DEPARTMENT OF PLANNING AND DEVELOPMENT
CITY OF CHICAGO

January 5, 2024

**Re: Minor Change to Residential-Business Planned Development No. 1522, Subarea A
901 N. Halsted St.**

PROPOSED SOUTH TOWER PERSPECTIVE

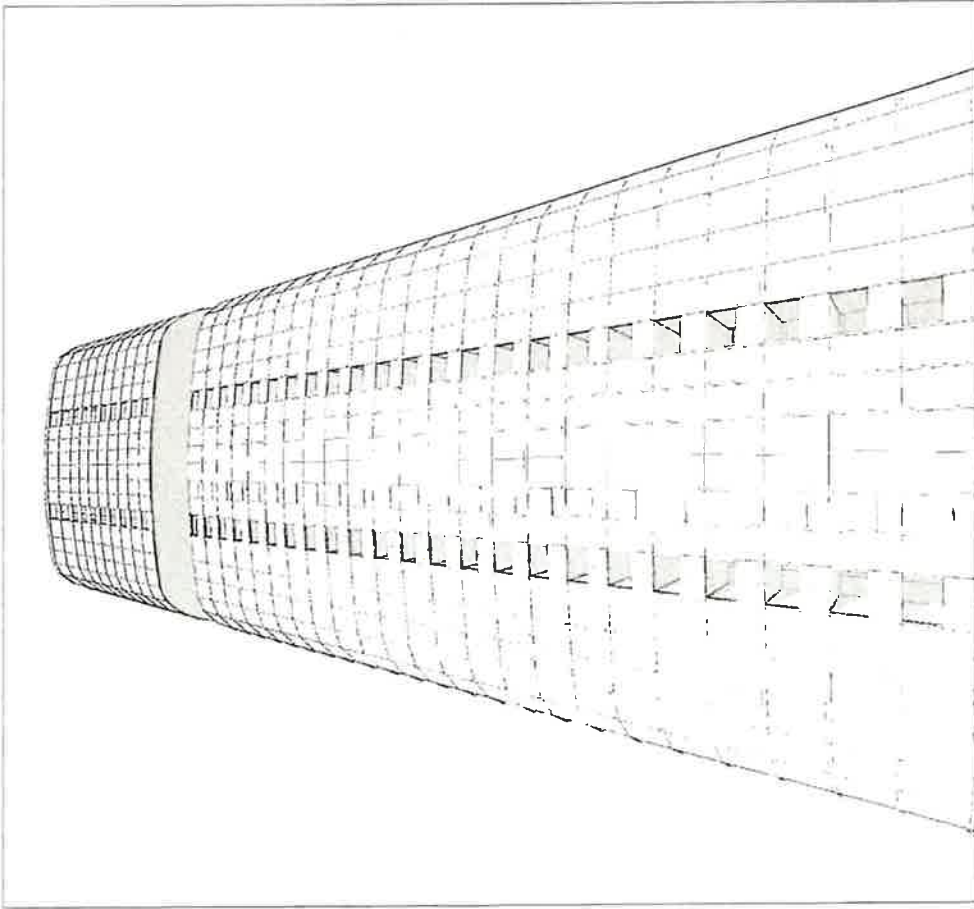
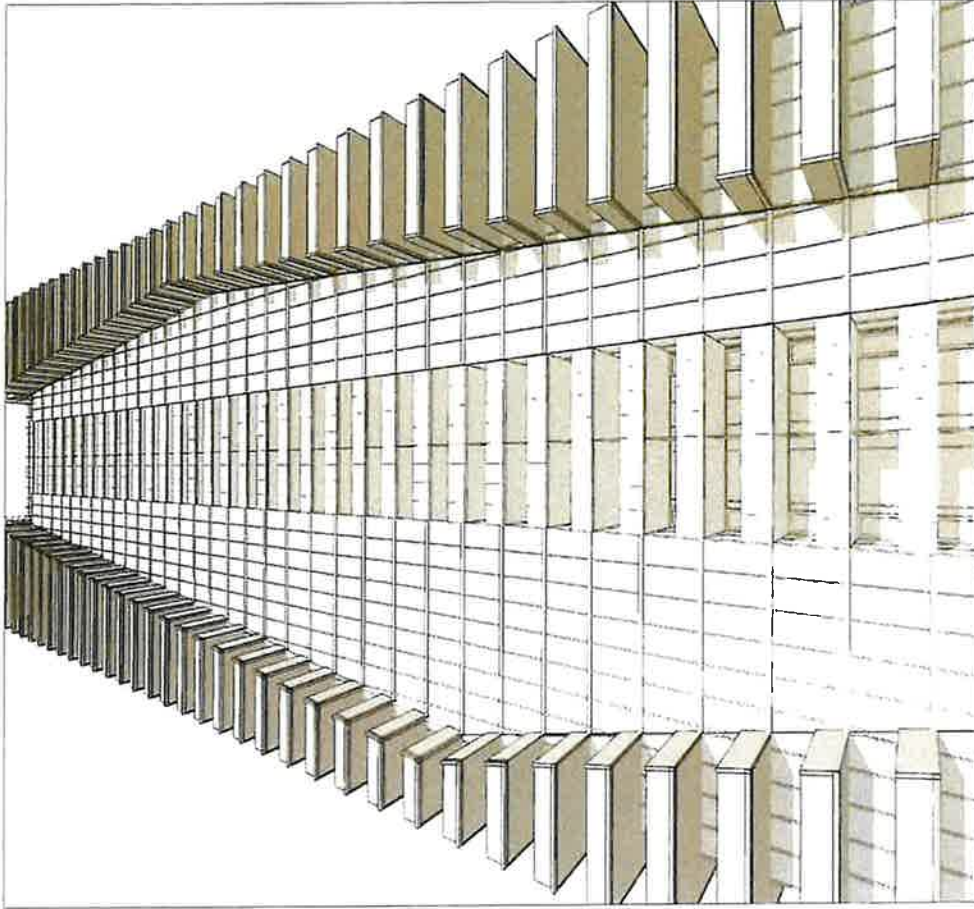
- > Height of building reduced
- > Revised facade on tower uses one captured glass system with (2) glazing and mullion colors
- > Corners of tower are squared off and more dynamic
- > Angular expression in the tower is followed through on top and base
- > Rooftop mechanical screen utilizes the same materials and architectural expression as base to create a more expressive and cohesive crown to building
- > Design of tower incorporates angled mullions and angled balcony walls
- > More depth and plane changes introduced to the tower facade
